CAP1616 Gateway documentation
Stage 1: Define Gateway

Design Principles
Realignment of Q36 and Q37 to accommodate Dublin Runway 2

V1.1

Figure 5: MoD Response Header (references to the separate Y124 ACP have been removed)

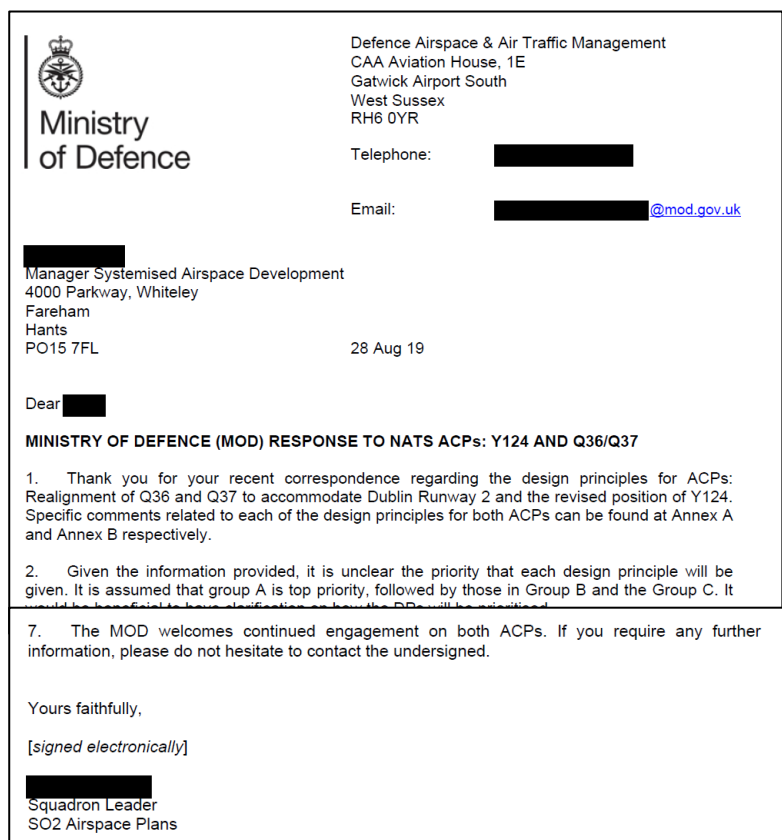
DP3 Operational (Dublin Rwy 2) (B)
The proposed amendments to the route structure will provide a compatible interface with the Dublin 2nd parallel runway project (Dublin SIDs and COP alignment) **MOD believe this should be a lower priority than DP6.**

DP7 Technical (Minimise CAS) (B)
The proposed changes are contained within the extent airspace (no additional airspace required) **MOD broadly agree, however seek assurance that there is no dependency re the Y124 ACP and that there no change or amendment required to existent adjacent airspace as part of this ACP.**

- The MoD suggested that DP3 (compatible interface with Dublin) should be a lower priority than DP6 (minimal MoD operational impact). NATS explained that the priority reflects the fact that the accommodation of dual runway operations at Dublin is the driver behind this ACP. However, minimal operational impact for the MoD is equally important hence the same priority.

- The MoD suggested that NATS seek assurance that there is no dependency between this ACP and the Y124 ACP and whether this would require a change to existing adjacent airspace. NATS noted this and confirmed that the two submissions are independent but will take the other design into account.
